# ENVIRONMENTAL REVIEW TEAM REPORT

## LITCHFIELD HILLS RESIDENTIAL COMMUNITY LITCHFIELD, CONNECTICUT

KING'S MARK  
ENVIRONMENTAL REVIEW TEAM REPORT  
ON  
LITCHFIELD HILLS RESIDENTIAL COMMUNITY  
LITCHFIELD, CONNECTICUT

DECEMBER 1980

FIGURE 6.  
SOIL AREAS WITH SEVERE  
LIMITATIONS FOR URBAN USES \*

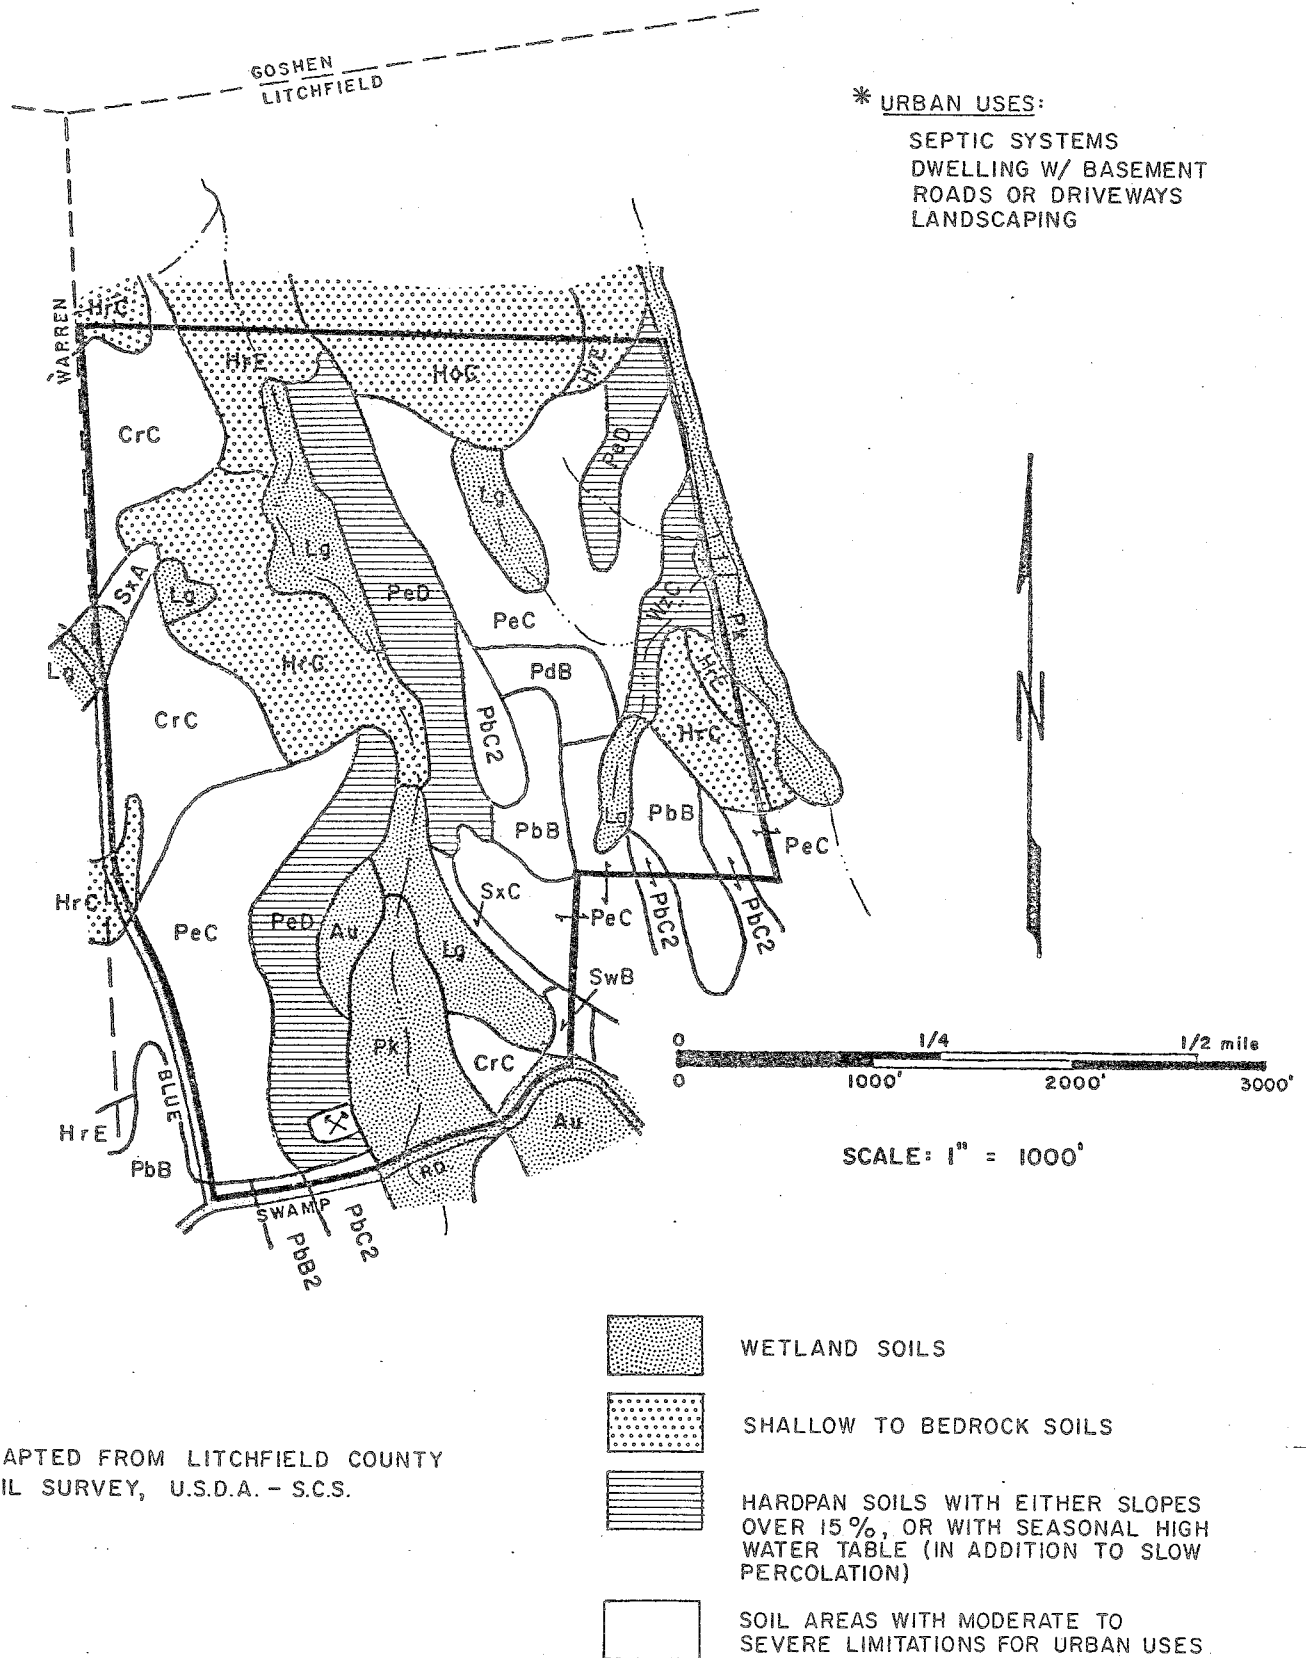
The great majority of soil areas with hardpan and slopes over 15% are indicated as "open space". The proposed single family detached units just above Phase I townhouses and in the northeast corner of the site would be partially located on the slopes over 15% with hardpan soils. If these soil areas are developed, costly measures will be required to overcome the severe limitations imposed by the steep slopes and hardpan.

A small area (+2 acres) in the southeasternmost "single family detached" section is indicated to be within a hardpan soil with a seasonal high water table (Woodbridge very stony fine sandy loam, 3-15% slopes). Any septic system that will function satisfactorily will be very difficult to design and install. Drainage and/or filling will necessary for most urban uses if this soil area is developed.

The remaining +115 acres (areas not screened in Figure 6) have soils with moderate to severe limitations for urban uses.

FIGURE 7.  
VEGETATION TYPE MAP

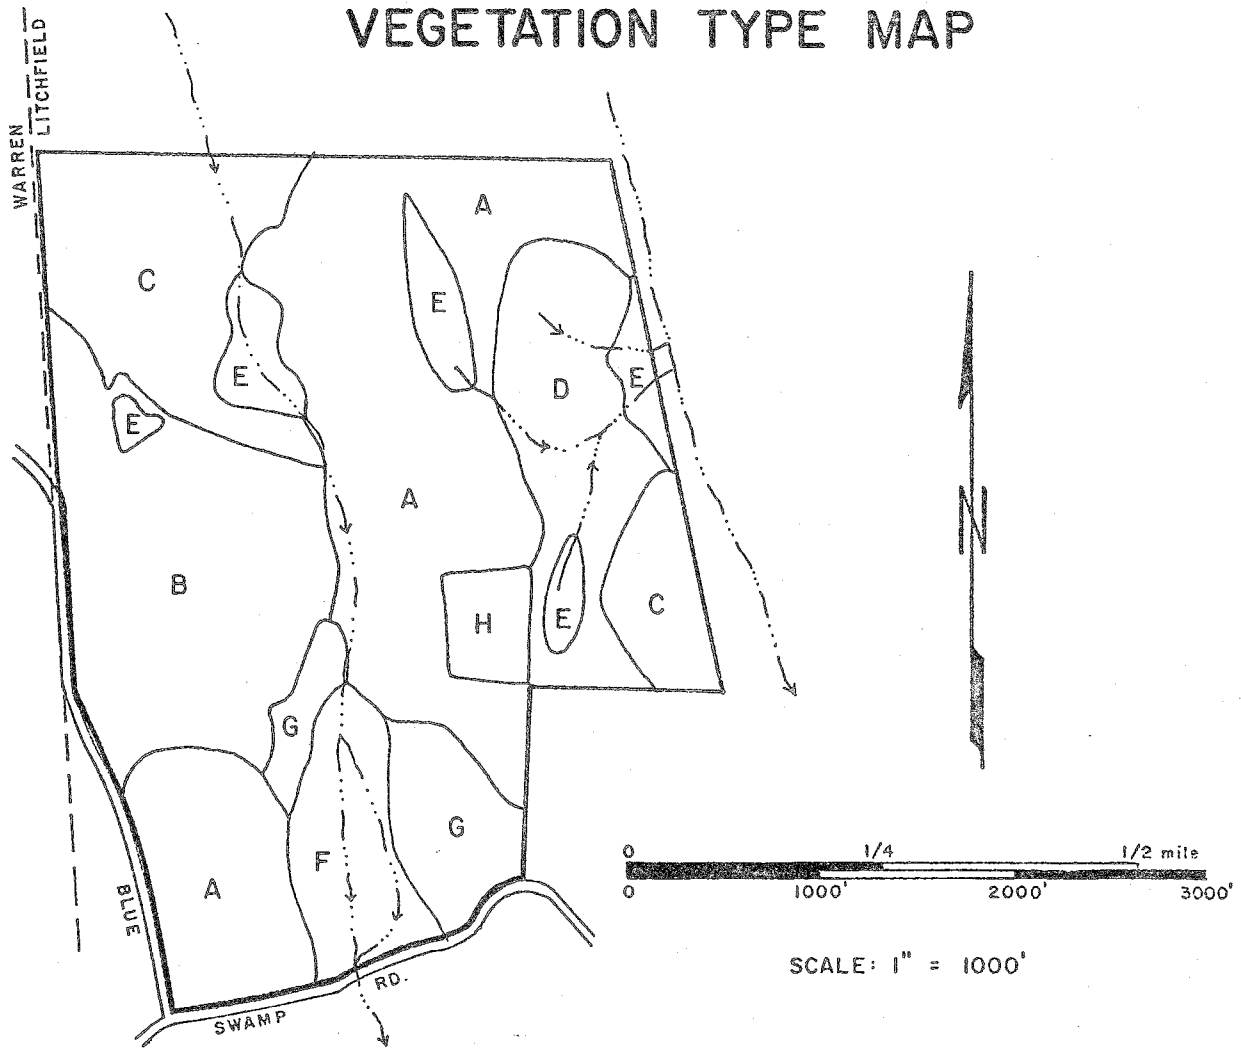
Many of the large healthy trees and flowering shrubs present within this tract have high aesthetic value and should be retained. The large open swamp provides many species of wildlife with high quality habitat. Windthrow is a potential hazard in the hardwood swamp and hemlock stand that may be intensified if development occurs in these areas. Care should be taken not to change drainage patterns in such a way that water ponds over tree and shrub roots and causes mortality. Portions of this tract would benefit by receiving a commercial harvest. Designation of large areas of open space will allow future forest management.

Many of the large healthy trees which are scattered throughout this property (especially in Vegetation Types A, B, D, and G) have aesthetic and shade value. These large trees should be retained to the greatest extent possible. Recent research has shown that trees on a house lot may enhance the value of that lot by as much as twenty percent.

The flowering shrubs, including mountain laurel which are present in vegetation types B, C, D and G have the potential to have high value for aesthetics, and therefore should be retained at least in patches throughout the property. The flowering of these shrubs may be stimulated by allowing direct sunlight to reach them. This may be accomplished by complete or partial removal of the overstory trees over these shrubs.

Vegetation type F, the open swamp, has high value for wildlife habitat. This area because of its dense herbaceous vegetation and partially open water provides food, cover, water and breeding areas for many species of song birds, small mammals and water fowl.

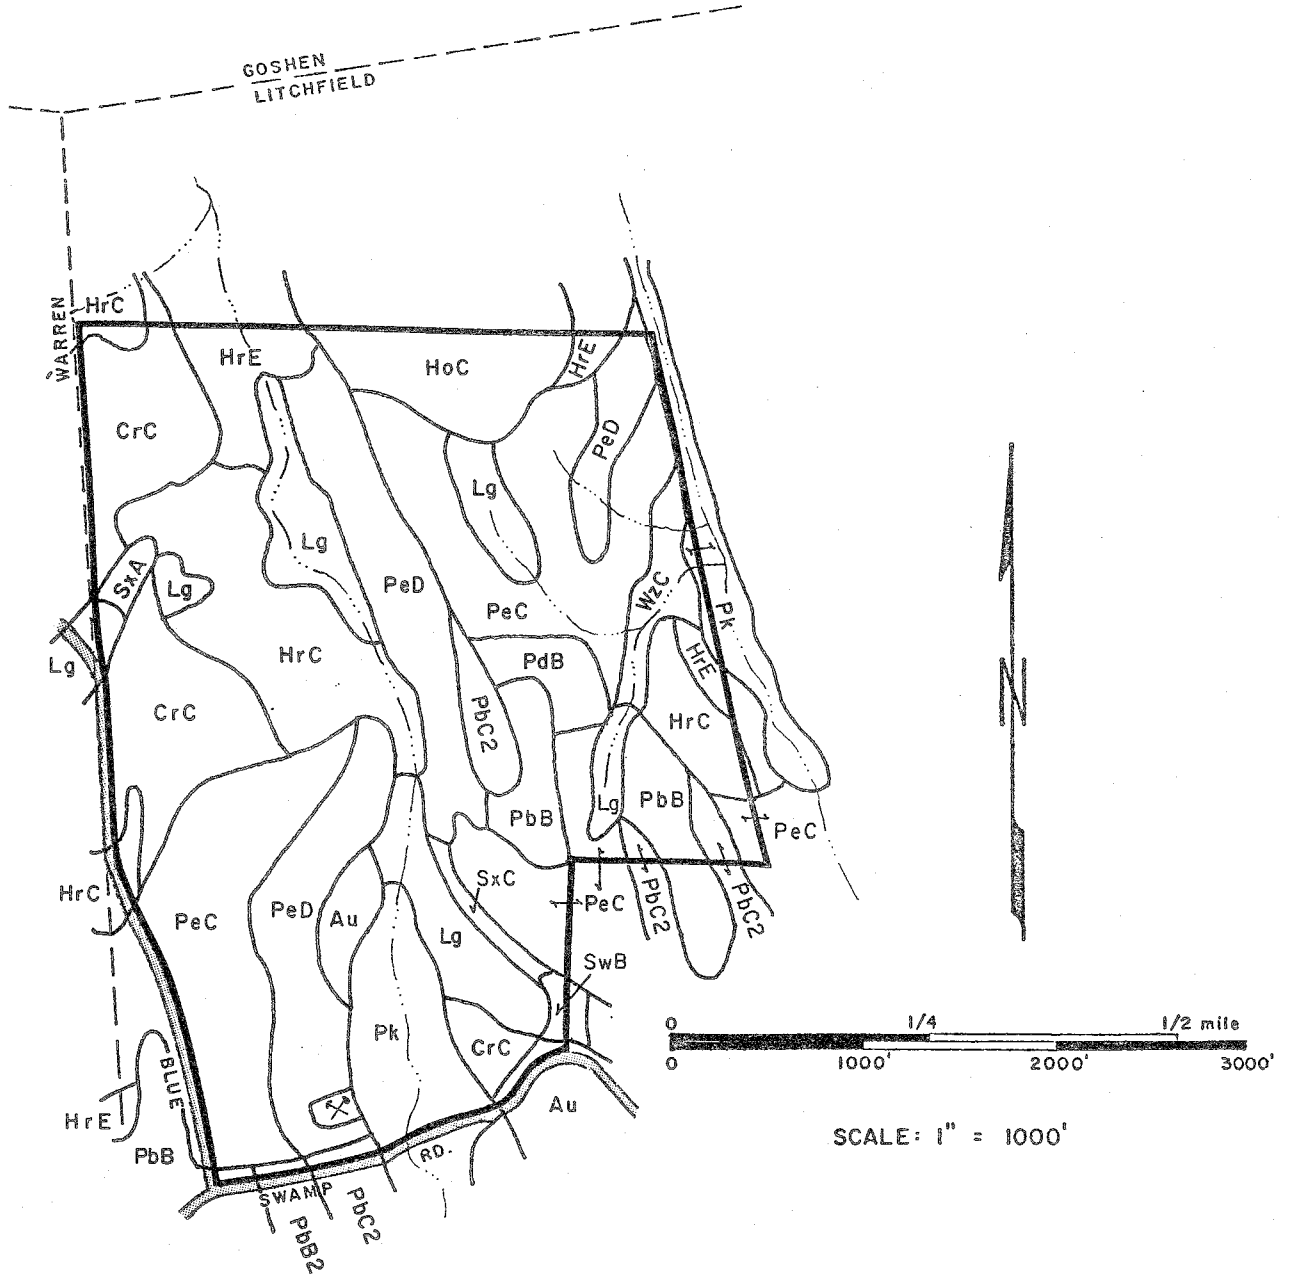
The soils and topographic information, in conjunction with the field inspection, suggest that the central portion of the site is essentially unbuildable, while the east and west sections contain areas of more suitable land. Assuming that about 172 acres of the site might be considered buildable, the guideline of 1 family per acre would suggest that a maximum of 172 units might be allowed on the site. Given the soil and terrain characteristics of the site and its location in a public water supply watershed, any cluster provisions permitted the developer should be given to allow him flexibility in using his good development areas rather than to increase the number of units allowed on the property.
